ADDENDUM #2

Reference: Greendale Maintenance Station Replacement
Utah Department of Transportation – Daggett County, Utah
DFCM Project No. 07029900

Subject: **Addendum No. 2**

2.4.1 The complete **drawing set has been revised and is re-issued with this Addendum.** Owner requested the deletion of the mezzanine and mezzanine access. Walls around office area extend 18'-0" A.F.F. Building footprint has been revised to incorporate larger truck bays. All drawings for all disciplines have been revised showing new building footprint & layout.

MAIN LEVEL LIGHTING PLAN

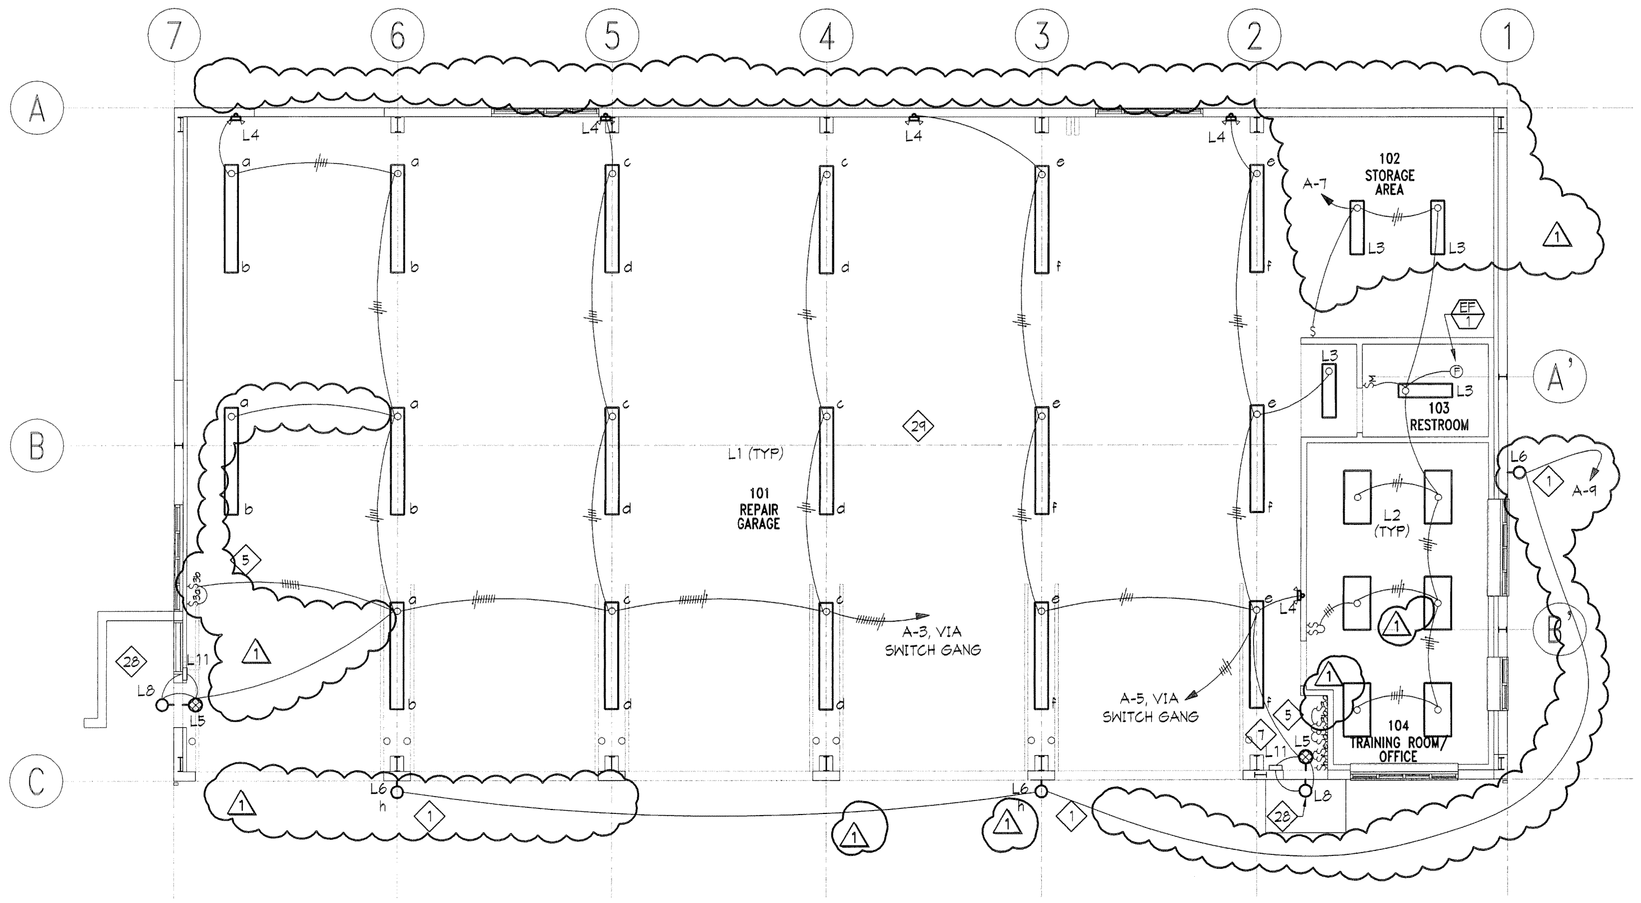
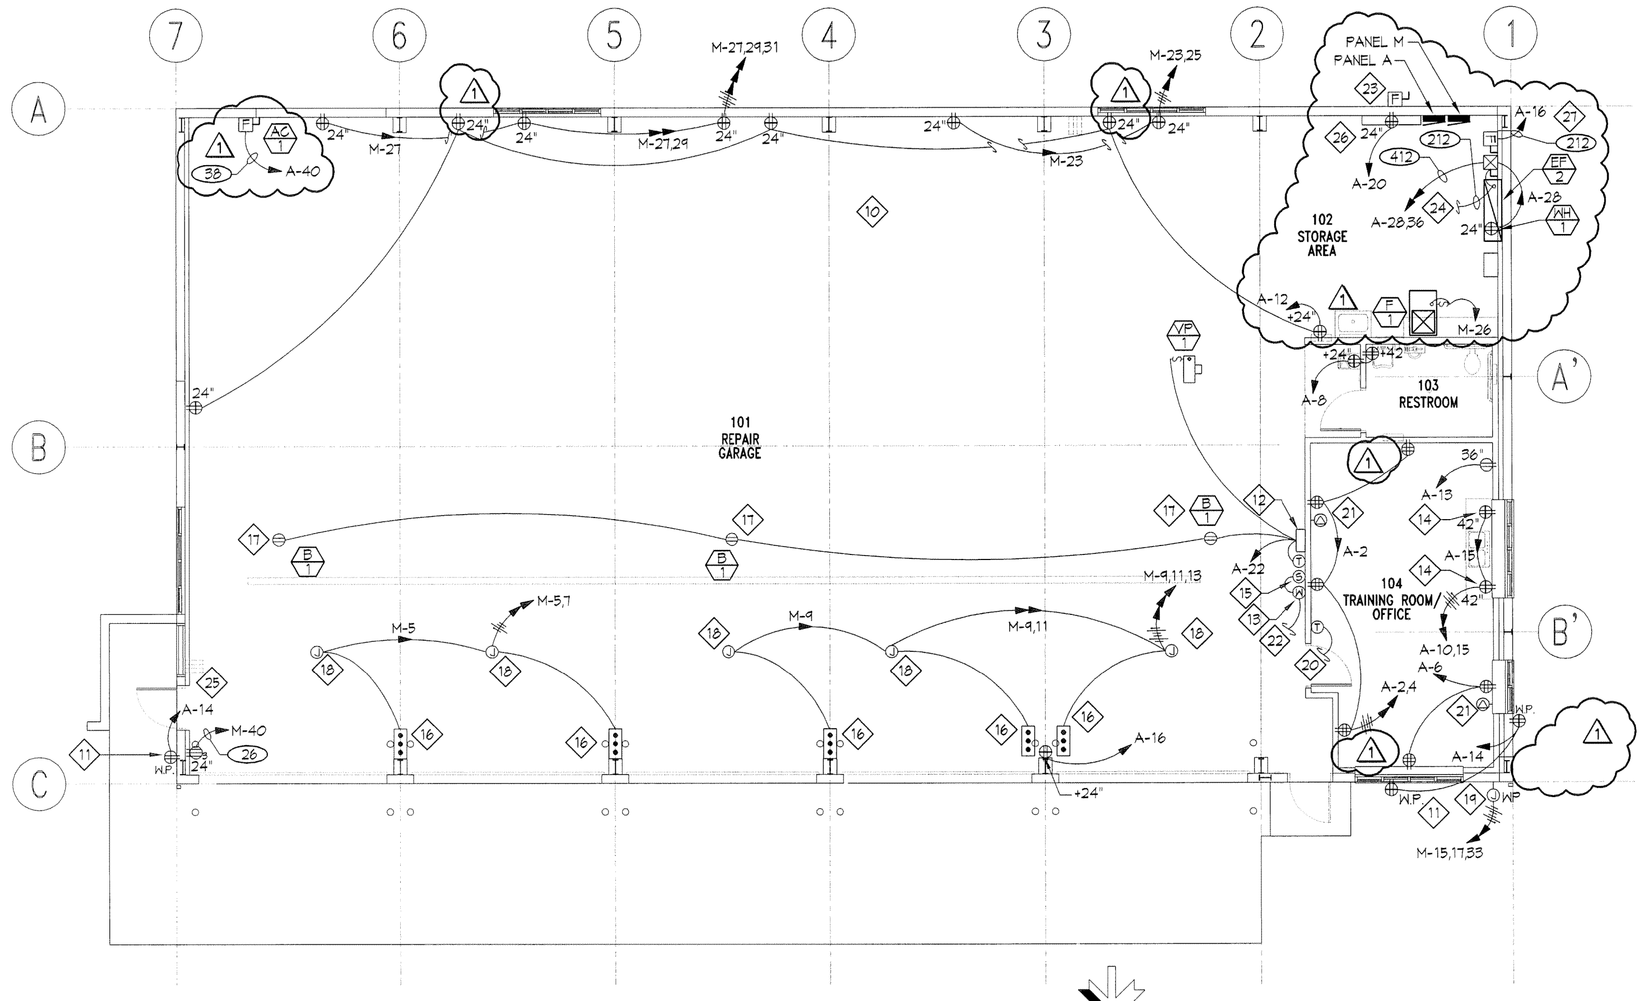
a Removed Mezzanine plan from drawing.
b Deleted Exterior Lighting Control Panel and associated Keynote 8.
c Removed exterior light from West side of building, two L6’s from North side and two L7’s from East side. Relocated on L6 from East side of Building to Gridline 6. Changed one L7 on North side to L6.
d Relocated lights in Storage Area to be centered in room. Added home run to circuit A-7.
e Removed Keynote 3 reference in Office Area.
f Added three-way switches for lights in Repair Garage.
g Removed one L1 fixture from Repair Garage closest to South door.
h Relocated convenience outlet in Storage Area.
i Relocated all equipment and circuits from Mezzanine to Storage area.
j Removed two phone/data outlets form office area.

k Deleted CU-1 and all associated electrical equipment.
l Removed Gutter and Roof Heat Tap for back (West) of building.
m Added disconnect for AC-1 in SW corner of Repair Garage
n Removed Key Notes 2, 3, 4, 6, 7, 8 and 9. These notes all related to the mezzanine and Exterior Light Controls which were deleted.
